RE: Burger King – 5101 Gibson Blvd SE
Grading and Drainage Plan
Engineer's Stamp Date: 09/26/18
Hydrology File: L18D084

RE: 5101 Gibson Blvd SE (Burger King) (L18D084)

RE: Burger King – 5101 Gibson Blvd SE
Grading and Drainage Plan
Engineer's Stamp Date: 09/04/18
Hydrology File: L18D084

ENGINEER'S SEAL	Title: BURGER KING 5101 GIBSON BLVD SE	DRAWN BY DATE
		GRADING AND DRAINAGE PLAN	SHEET # 1 of 2
		RHD Engineering, LLC 4305 Purple Sage Ave. NW ALBUQUERQUE, NM 87120 (505) 288-1621	JOB #

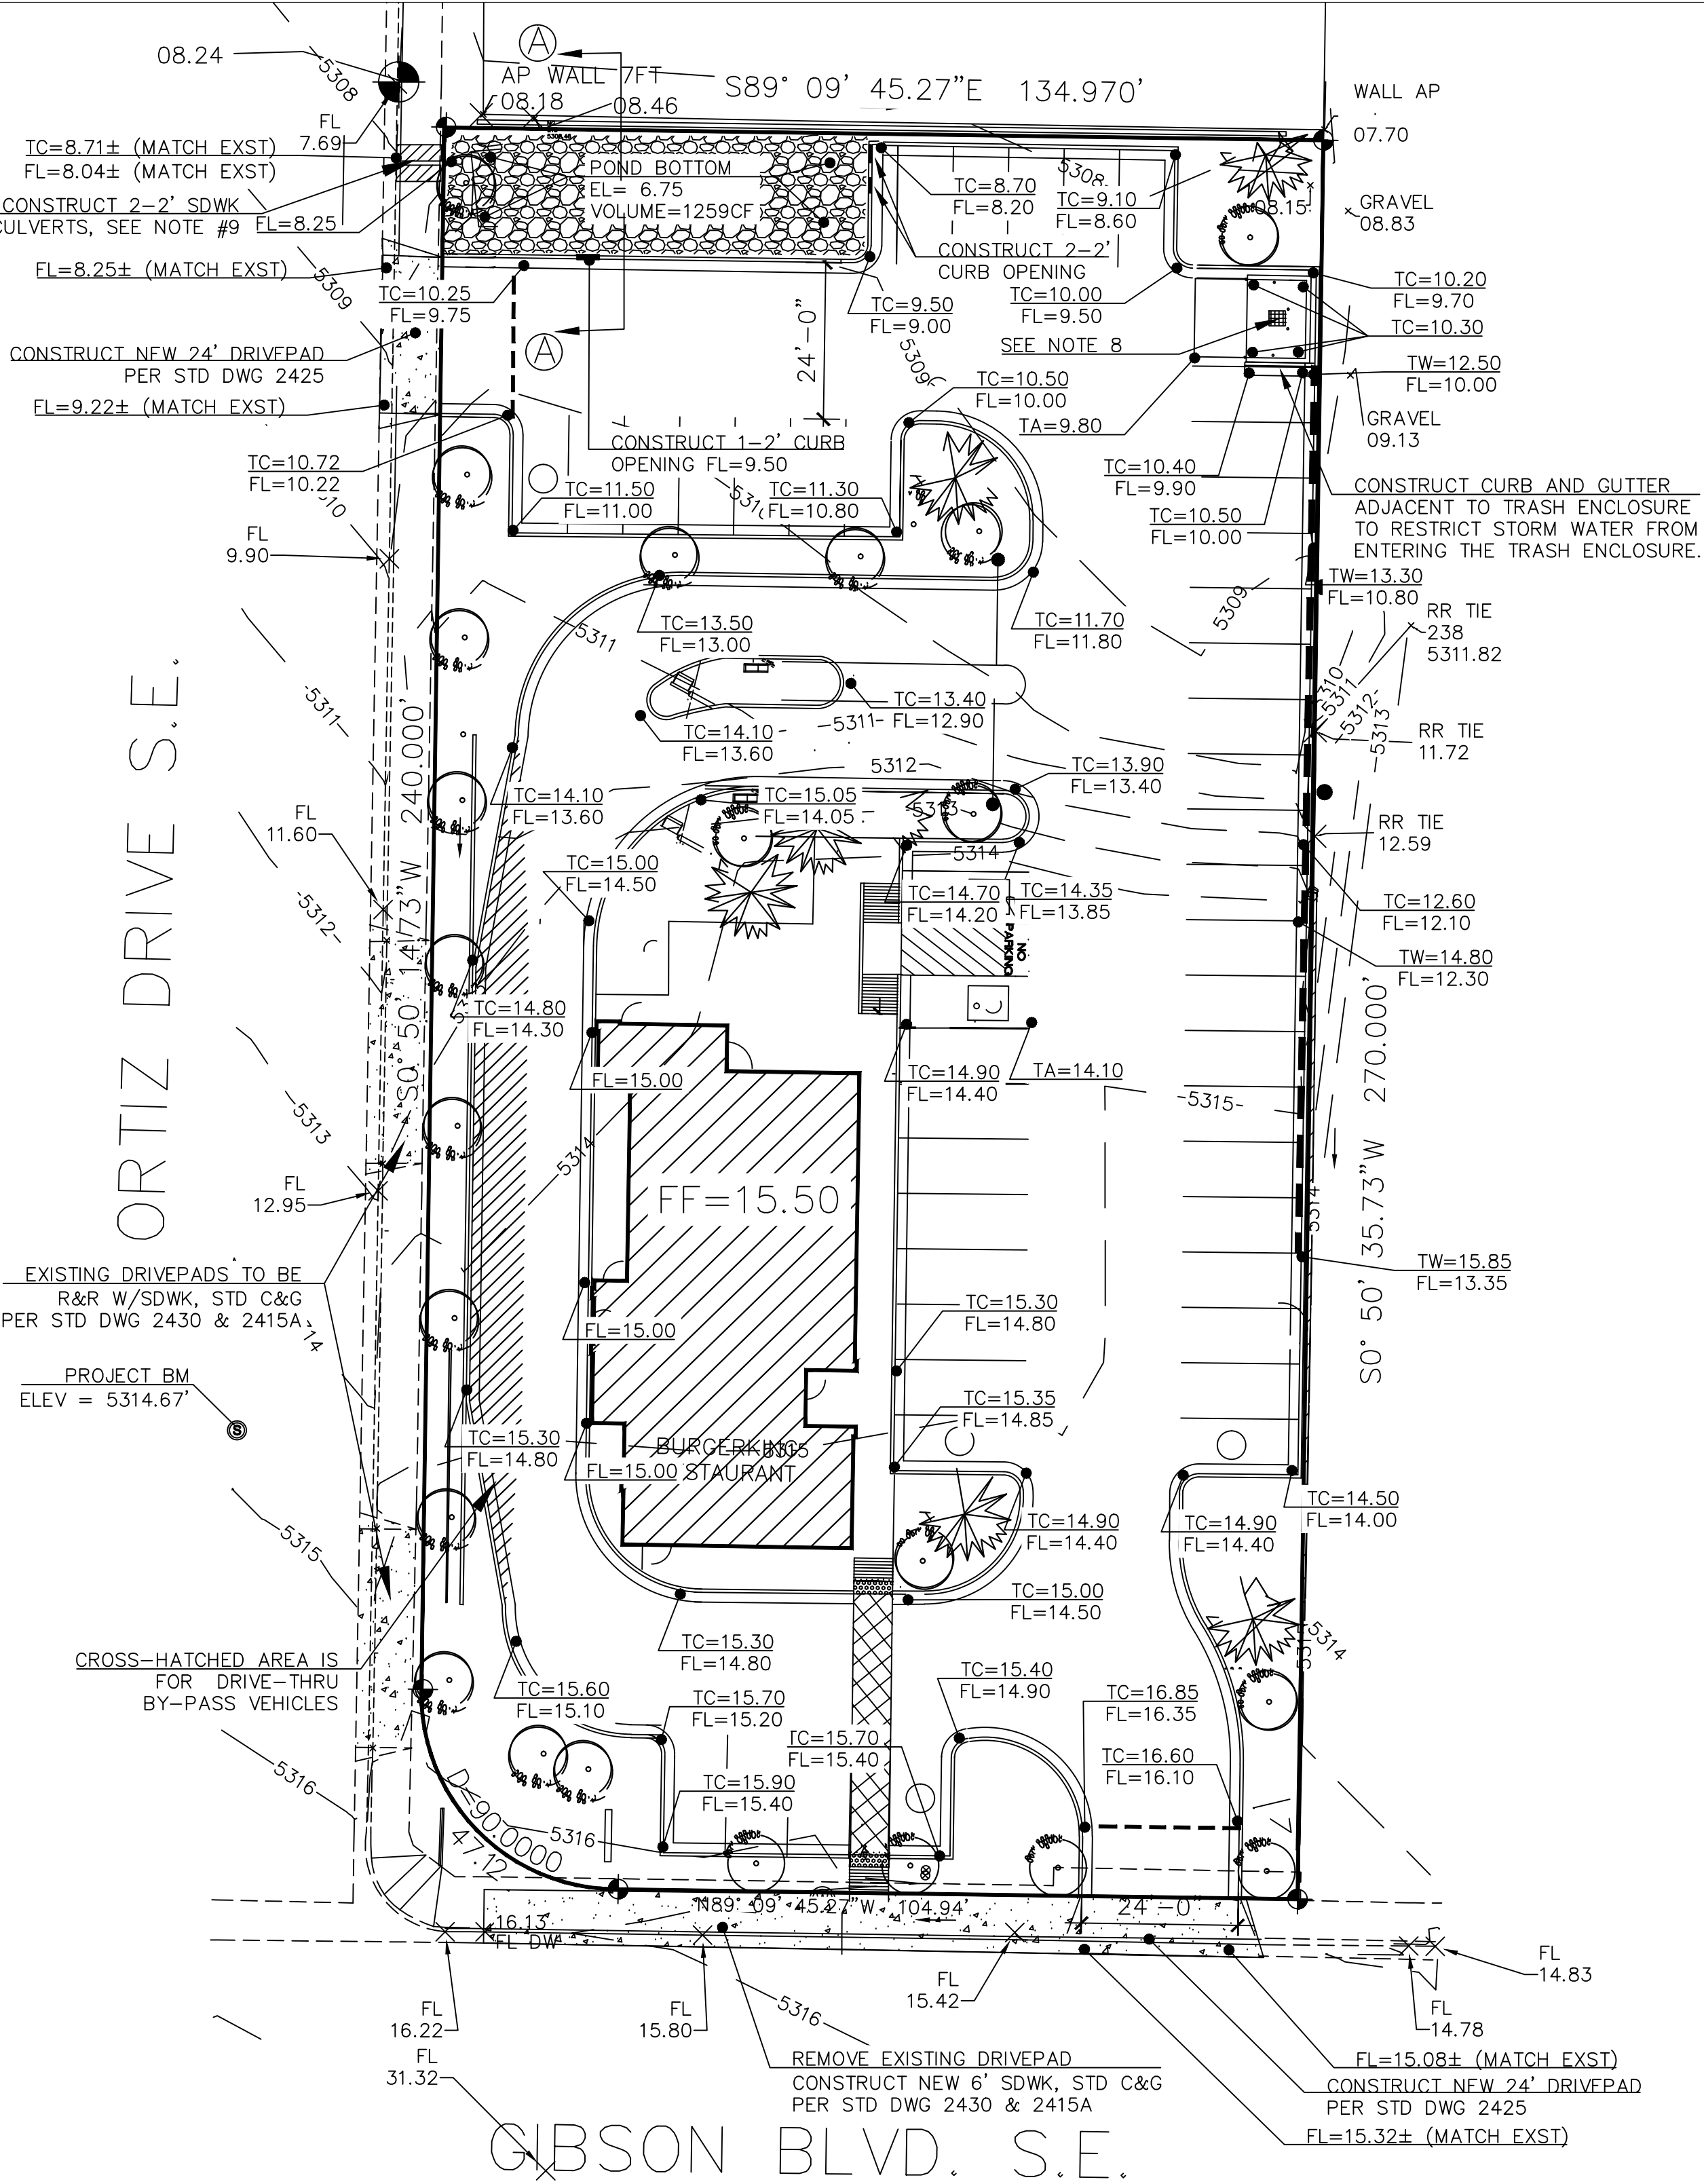
1. Please provide the benchmark information for the survey contour information provided.

2. Please add the effective date of the FIRM Map to General Note #1.

3. The storm water quality volume is calculated based on the 0.44 inch storm. To calculate the required storm water quality volume to be captured, multiply the impervious area (SF) by 0.34 inches for the 90th percentile storm. Please redo the first flush calculations. The required volume should be 9,572 CF.

4. Near the dumpster, please change the inlet reference note to note 8.

5. Please clarify what the hatching in the pavement on the West side of the building is.

7. Near the dumpster, please redirect the sheet flow around the dumpster so that the runoff will discharge into the first flush pond and not the inlet that is in the dumpster enclosure.

1. Bench mark information has been included.
2. FIRM map information has been added.
3. The storm water quality calculation has been changed.
4. Note for the dumpster has been changed.
5. Pavement hatching note has been added.
6. Top of wall and flowline spot elevations have been added, along with the clarification of the section adjacent to the wall.
7. A curb has been added adjacent to the dumpster enclosure to keep storm water out of the dumpster area.

GARDEN WALL/RETAINING WALL DETAIL

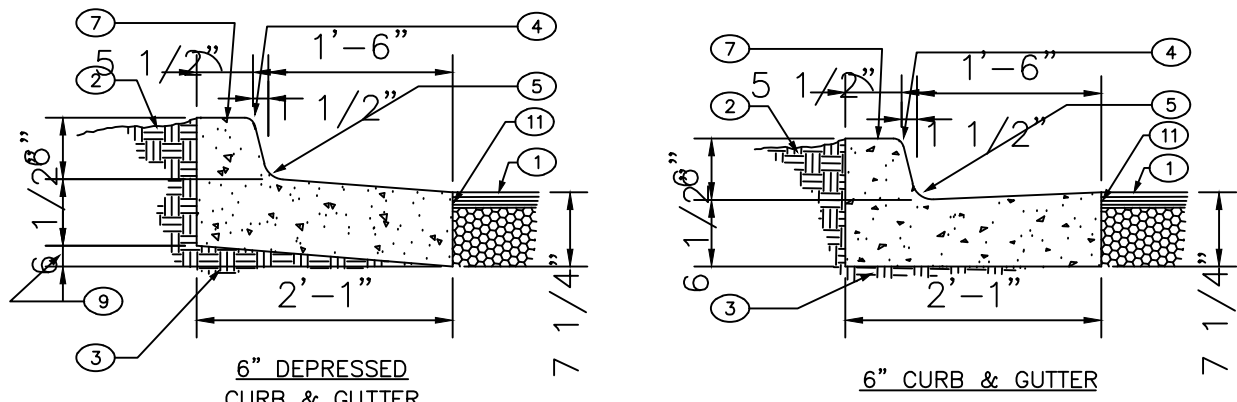
6. Please add the top of wall and flow line information to the proposed garden/retaining wall. Also please clarify in the detail on Sheet 2 is the curb going to be right next to the wall or is the wall acting as the curb for the parking lot?
